SUBJECT: LICENSE AMENDMENT REGARDING EXXON FUEL RELOAD

RE: GRAND GULF NUCLEAR STATION, UNIT 1

Amendment No. 23  
License No. NPF-29

ATTACHMENT TO LICENSE AMENDMENT NO. 23

FIGURE 3.2.1-1 MAXIMUM AVERAGE PLANAR LINEAR HEAT GENERATION RATE (MAPLHGR) VERSUS AVERAGE PLANAR EXPOSURE FOR CORE FUEL TYPES 8CR210, 8CR160, AND XN-1

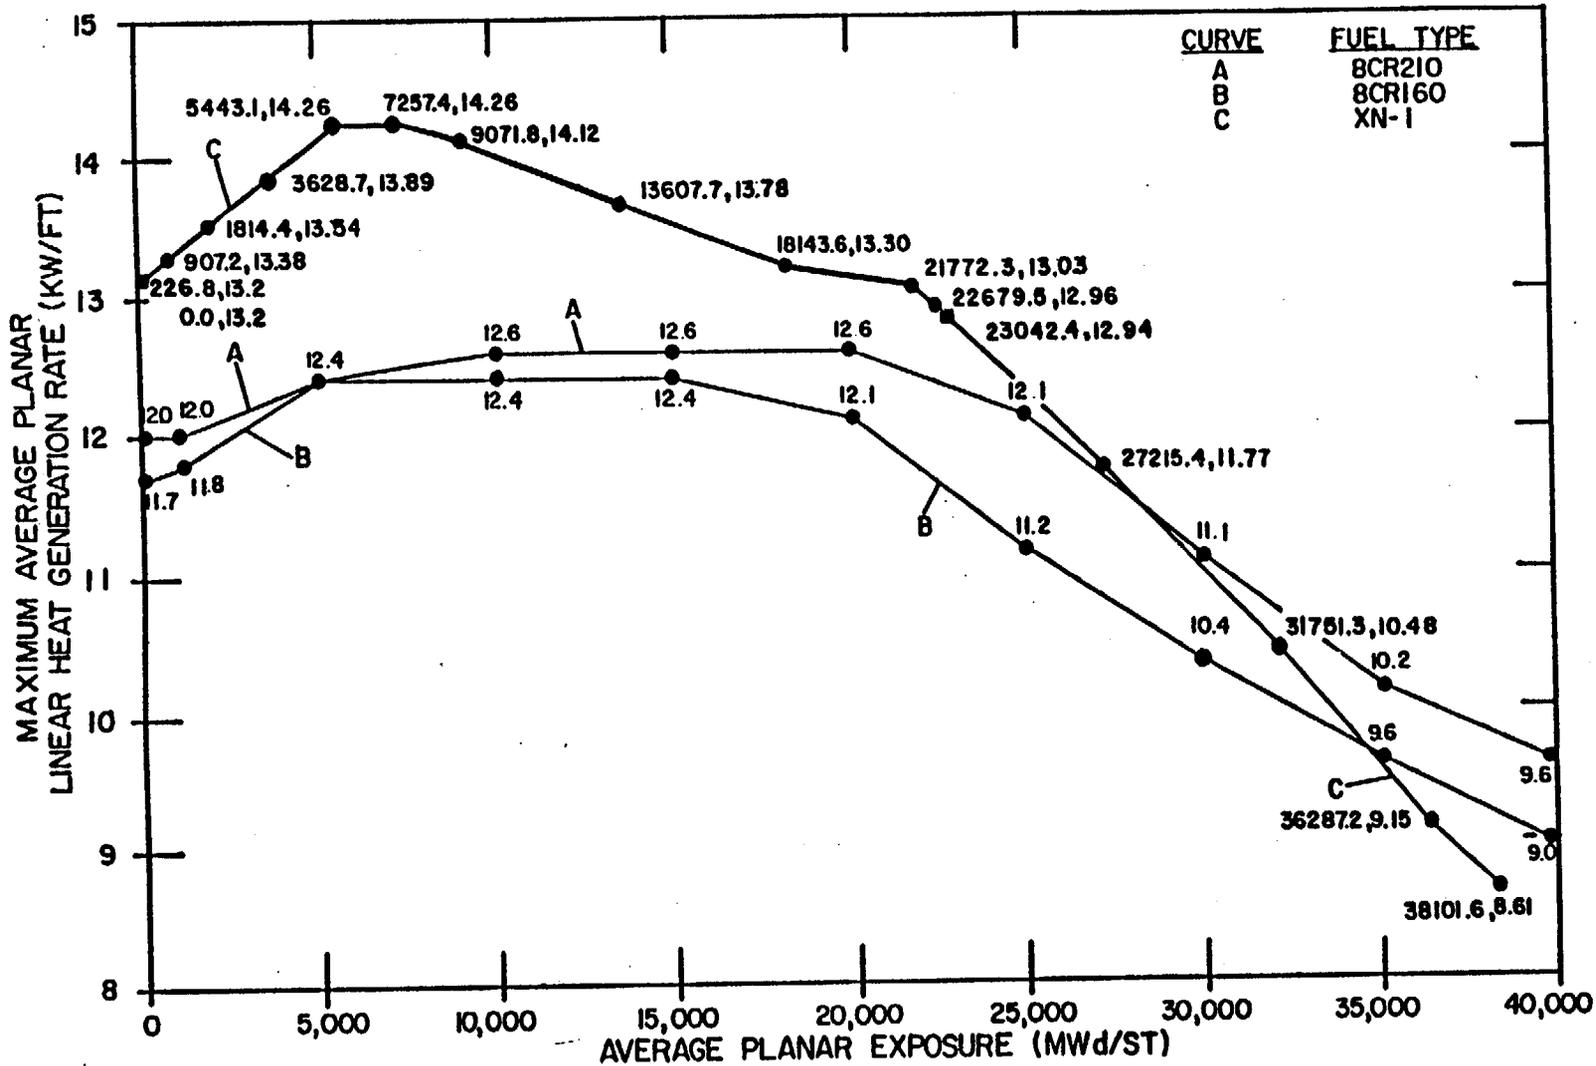
- (4) Figure 3.2.1-1: The MAPLHGR curve for the GE low enrichment fuel assembly from the previous cycle, which is removed for Cycle 2, has been eliminated and replaced by the curve for the new Exxon fuel assembly. This curve is based on the Exxon LOCA calculations and is acceptable.

FIGURE 3.2.1-2 MAPFAC<sub>f</sub>

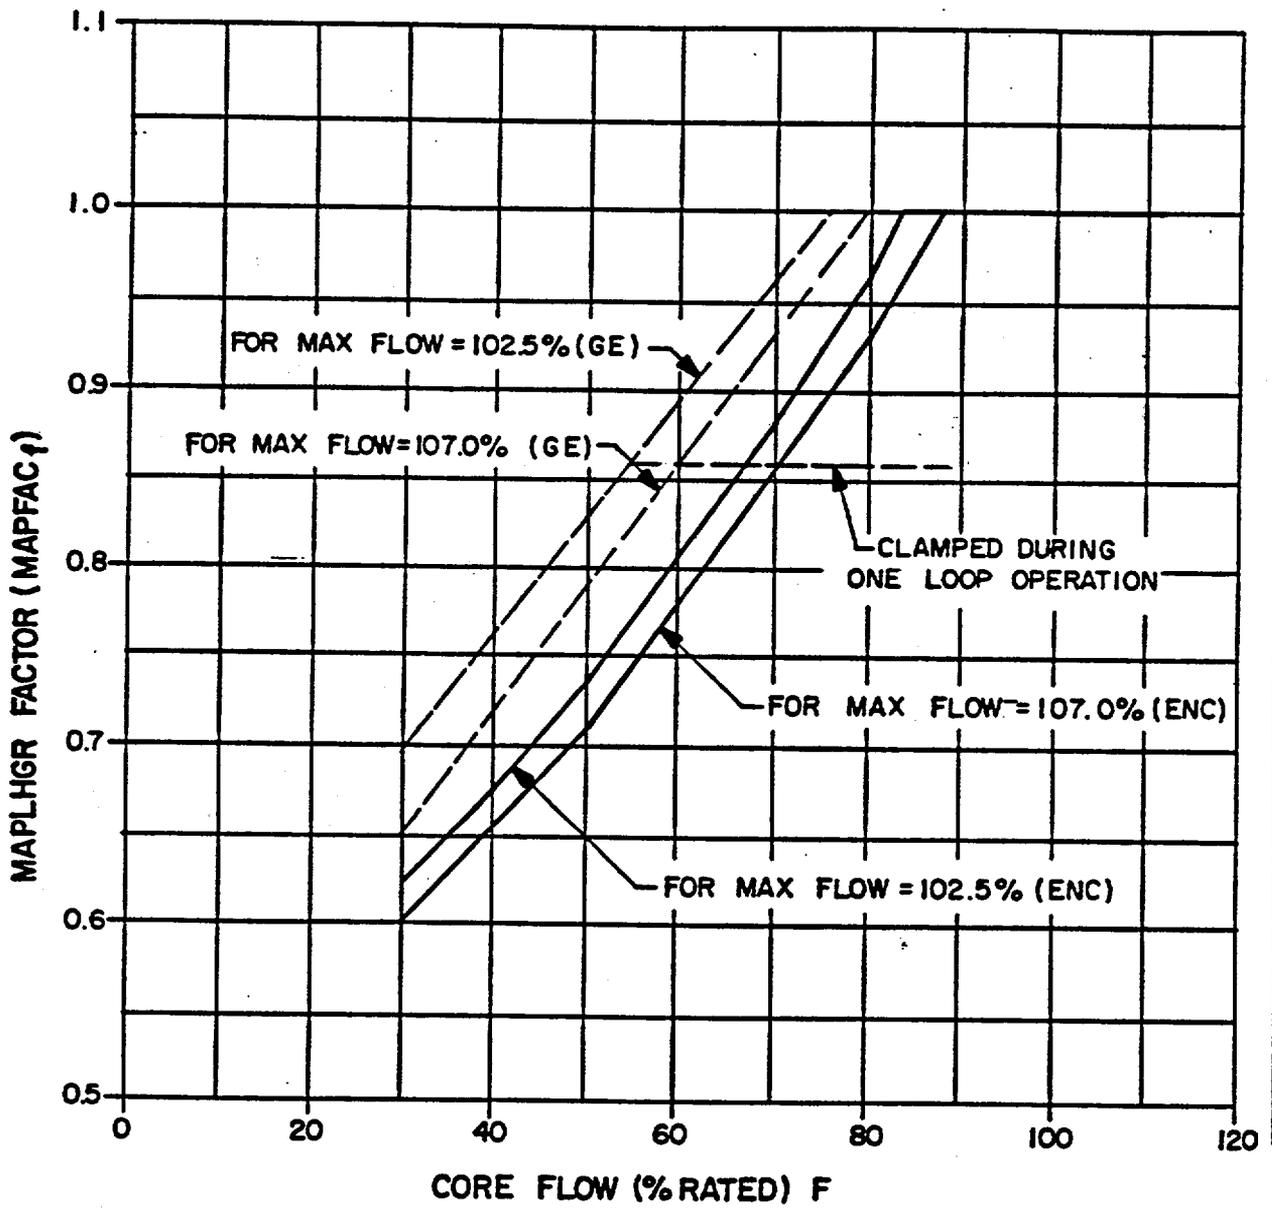
- (5) Figure 3.2.1-2: MAPFAC<sub>f</sub> curves for the Exxon fuel assembly have been added to the existing curves for GE fuel. These are based on the Exxon calculations of flow increase transients and are acceptable.

FIGURE 3.2.4-1 LINEAR HEAT GENERATION RATE (LHGR) LIMIT VERSUS AVERAGE PLANAR EXPOSURE EXXON 8x8 FUEL

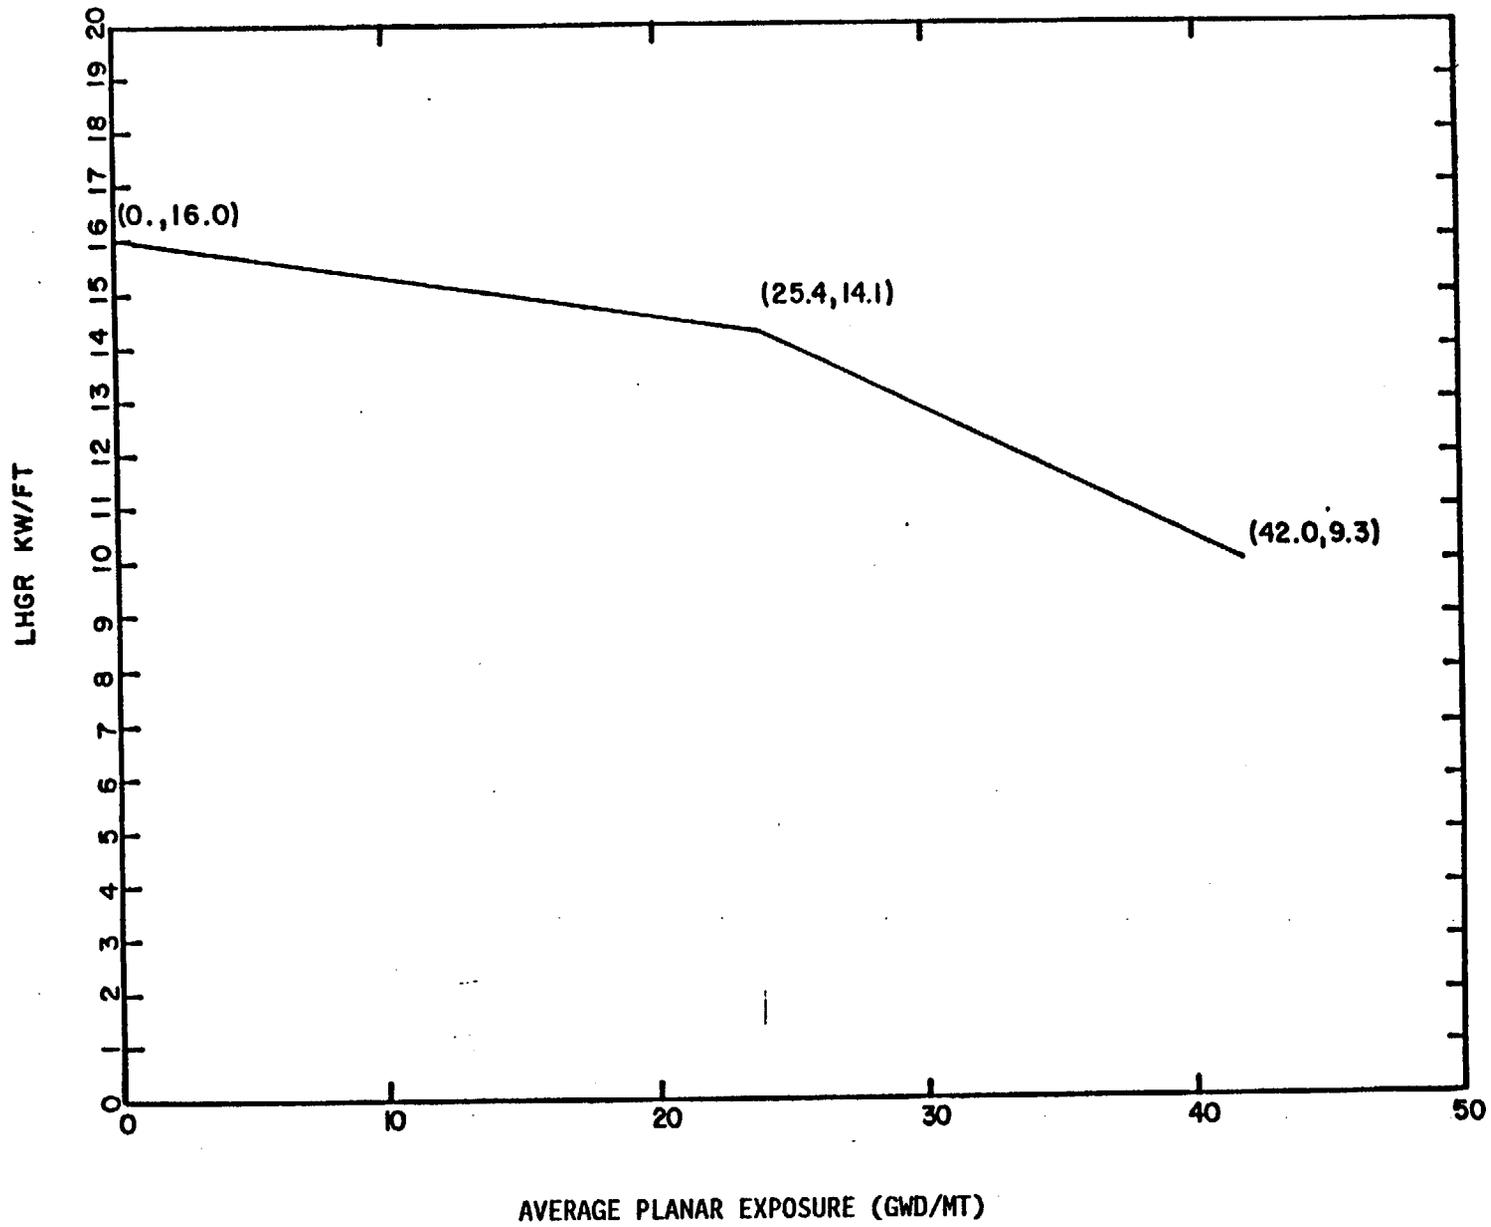
- (6) TS-3/4.2.4: This specification has been changed to add a reference to Figure 3.2.4-1 giving the Linear Heat Generation Rate (LHGR) curve for Exxon fuel. The GE fuel LHGR remains at 13.4 kw/ft. This is acceptable.

- (7) Figure 3.2.4-1 has been added to give the Exxon fuel LHGR limit as a function of burnup. This is similar to previously approved curves for Susquehanna and WNP2. It is based on approved methods for Exxon fuel mechanical design analyses, and is compatible via the local peaking factor with the MAPLHGR limit of Figure 3.2.1-1 (Ref. 2). It is acceptable.

FIGURE 3.4.1.1-1 POWER-FLOW OPERATING MAP

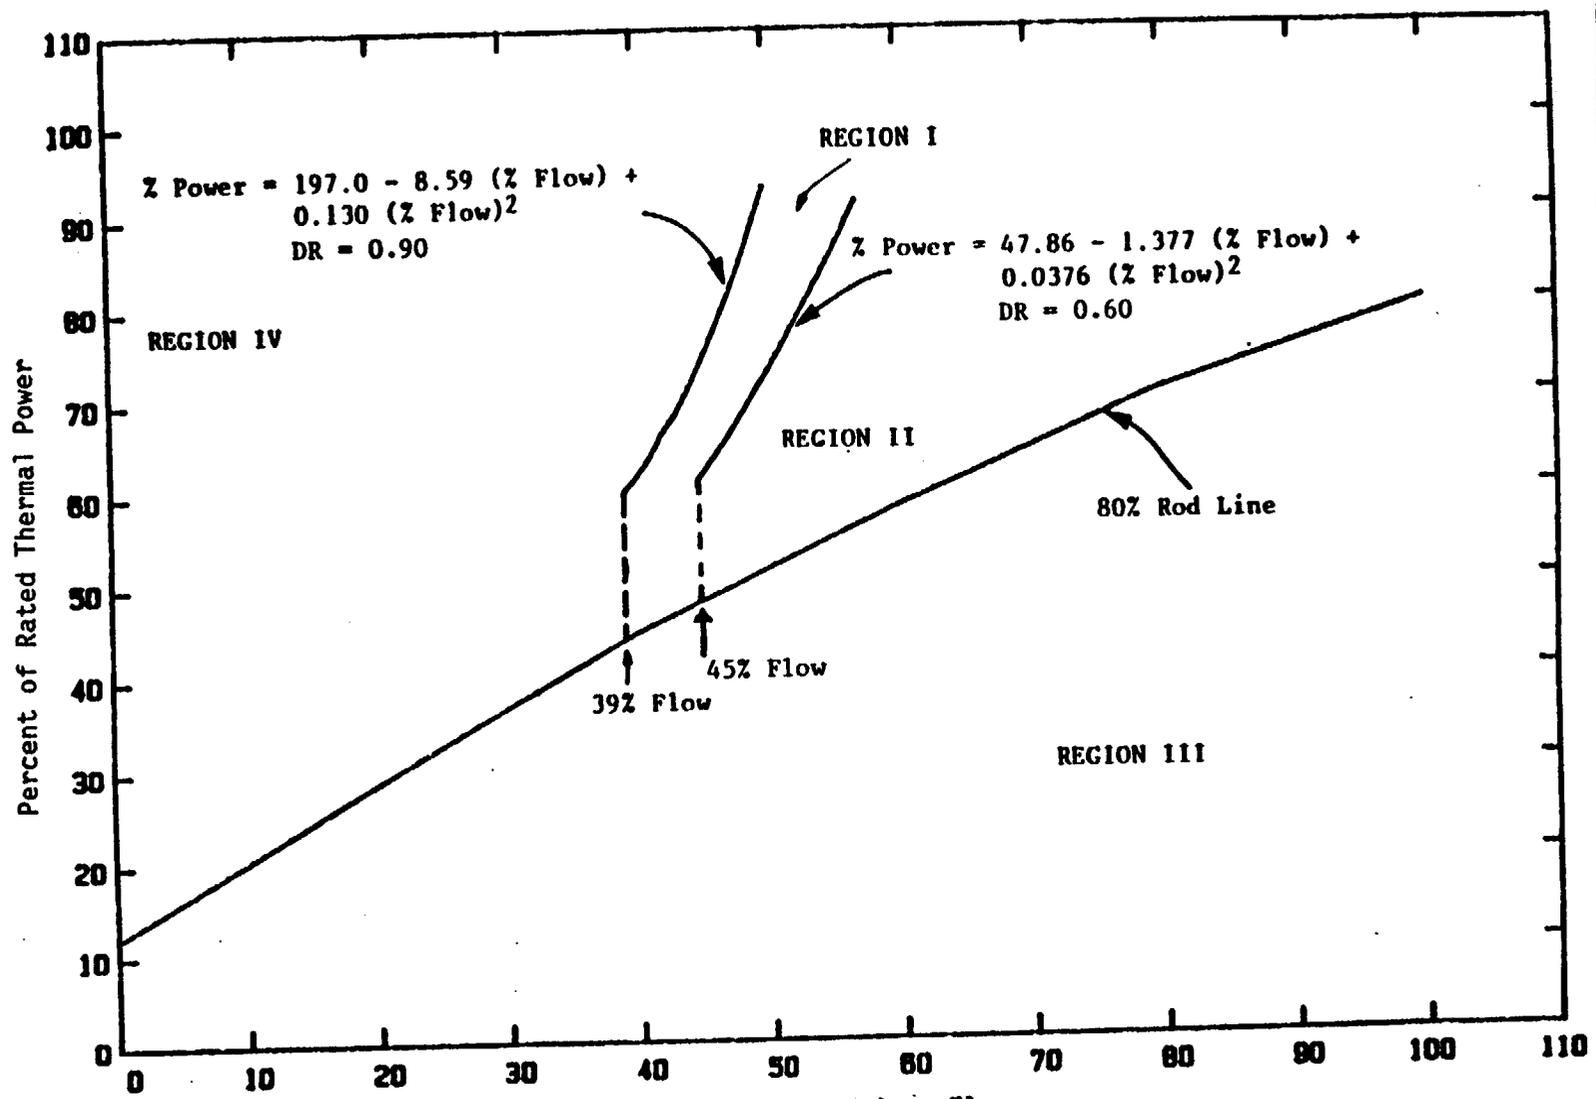
- (8) Figure 3.4.1.1-1: As discussed in Section 2.4 on thermal-hydraulic stability, the power-flow plane regions requiring monitoring or no operation have been changed. The final version of the figure giving these regions was presented in Reference 7. It is acceptable.
